CITY OF ALBUQUERQUE

January 27, 2015

**Re: Mile High Little League
Grading and Drainage Plan
Sheets 4, 5, & 6 of 11 With Engineer's Stamp Date 1/21/2015, (K21/D002A)**

**MILE HIGH LITTLE LEAGUE SITE IMPROVEMENTS
GRADING AND DRAINAGE PLAN - NORTH**

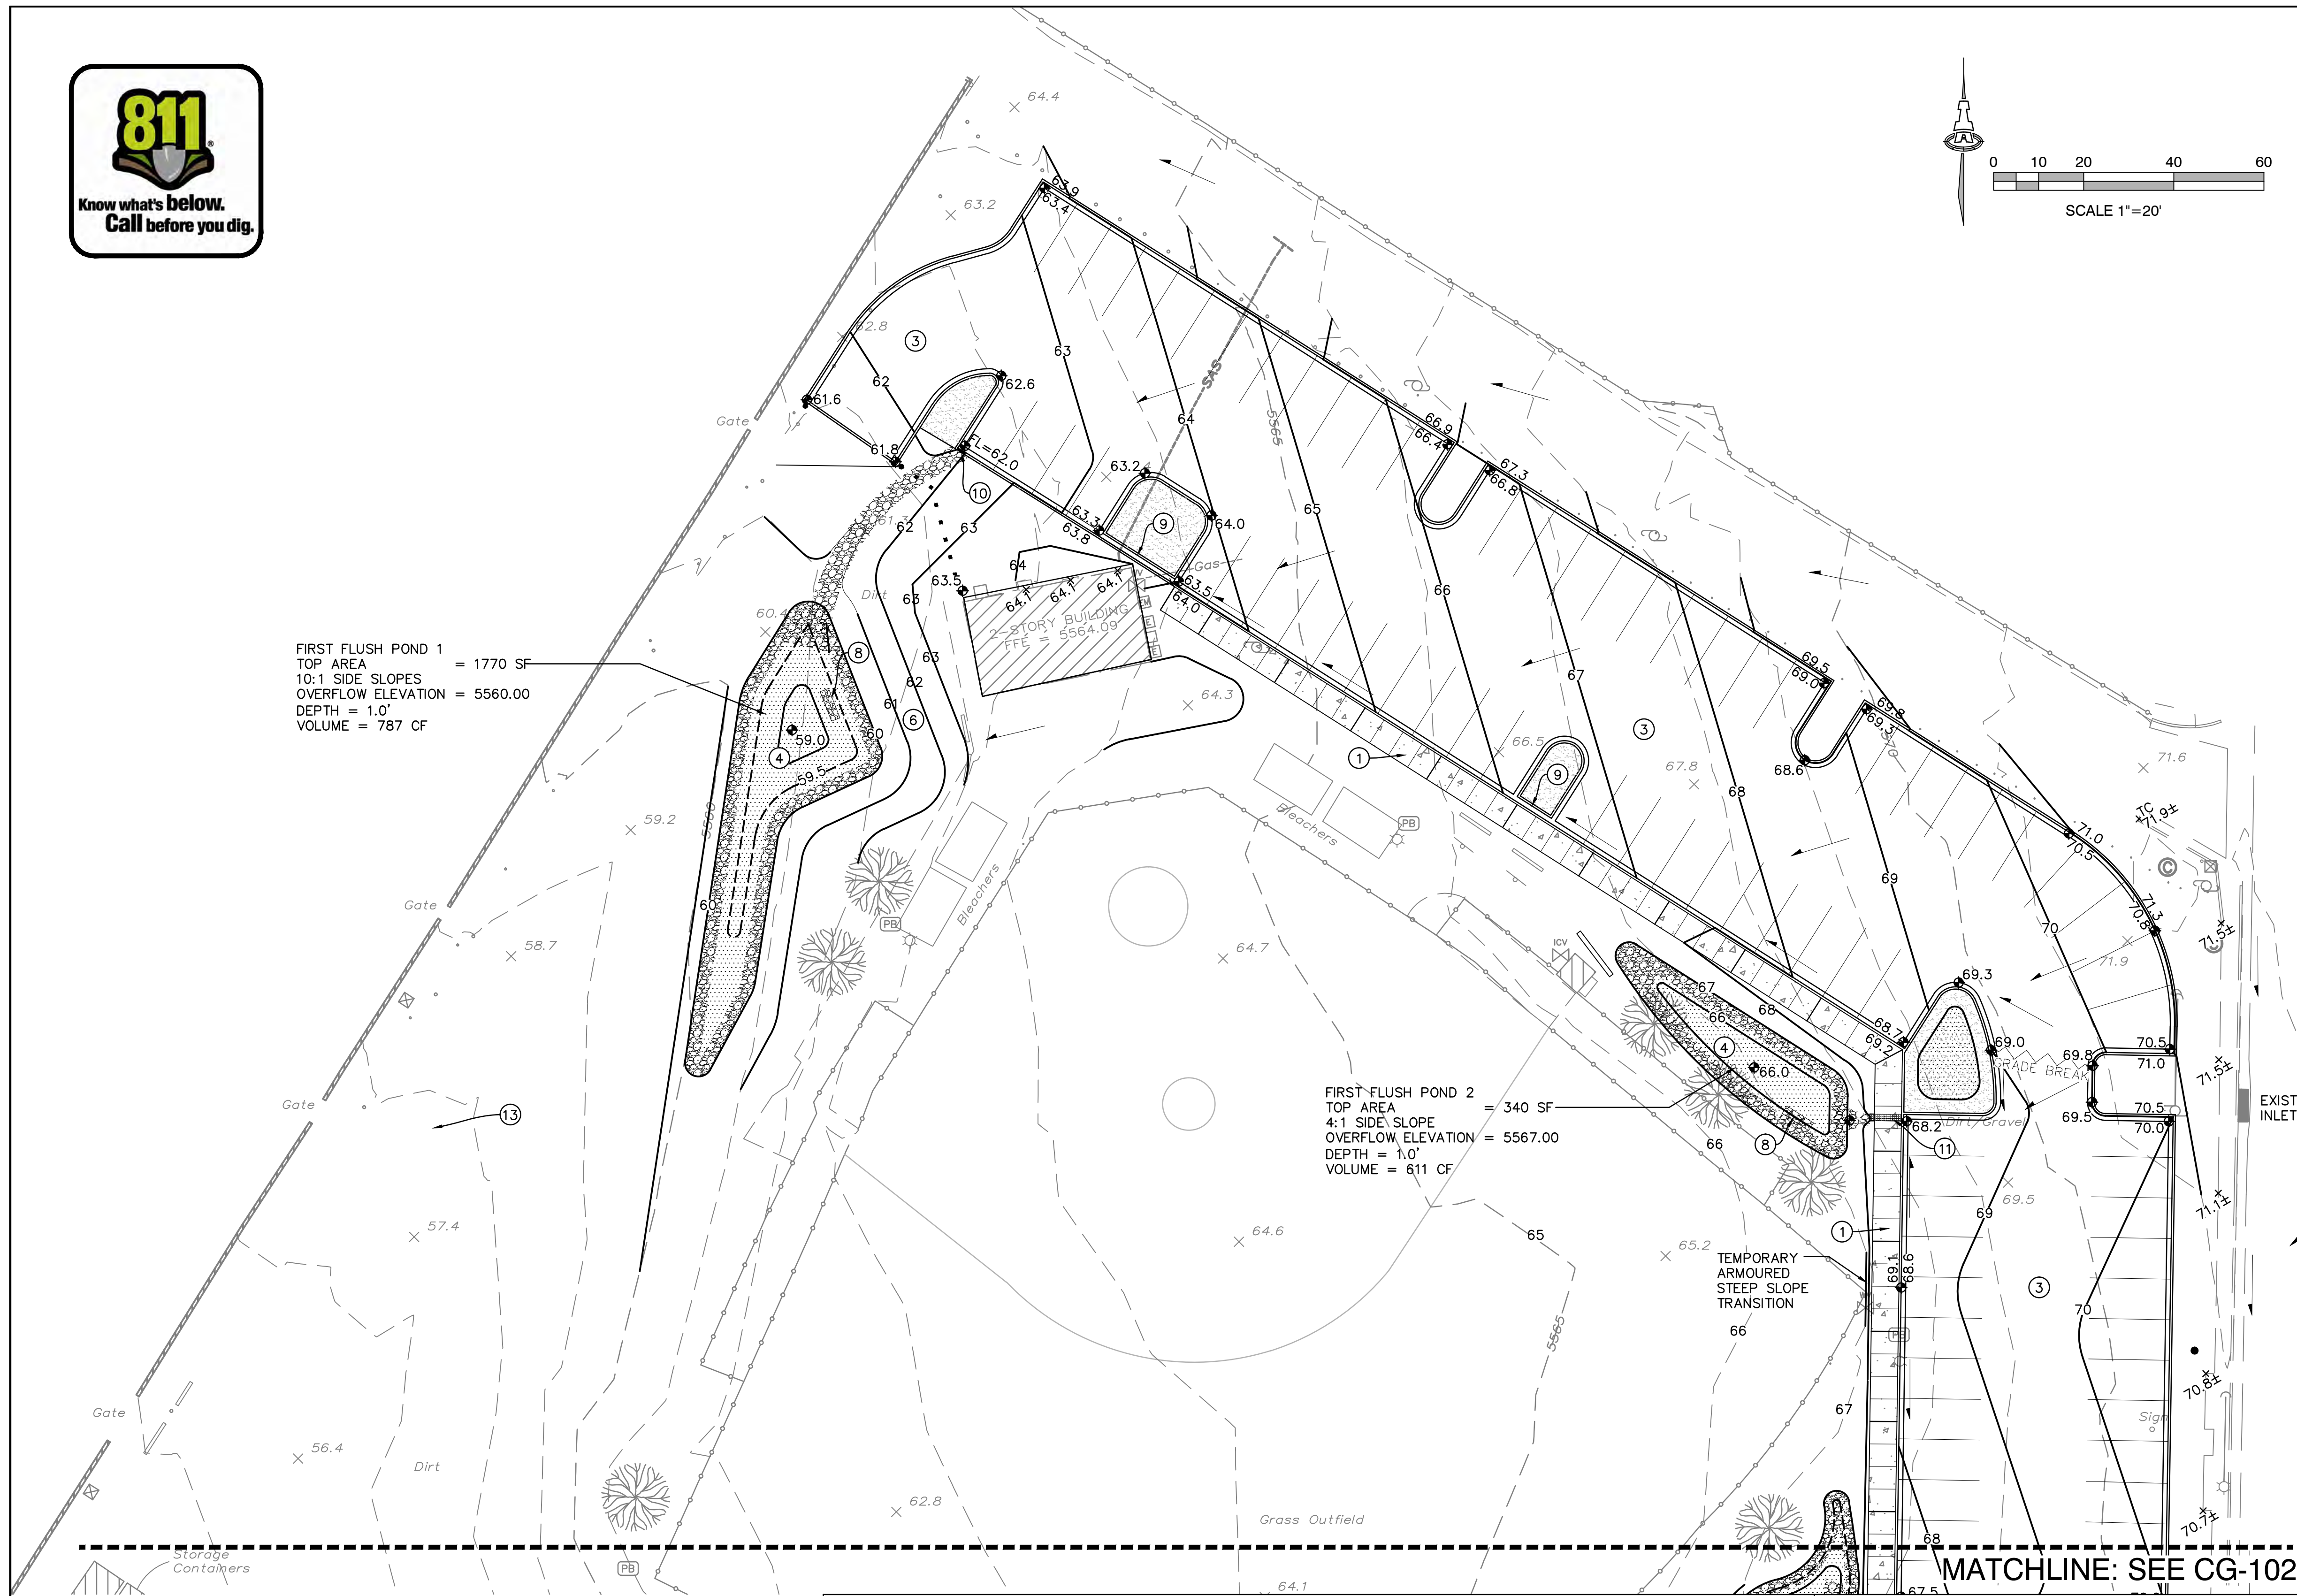
Based upon the information provided in your submittal received 1-22-15, the grading and Drainage Plan is approved for Grading and Paving Permit. Please make sure that the grades around handicap parking are adjusted based on the changes on the site plan with Landscape Architect Stamp Date 1/26/2015 (Sheets 7, 8, & 11 of 11).
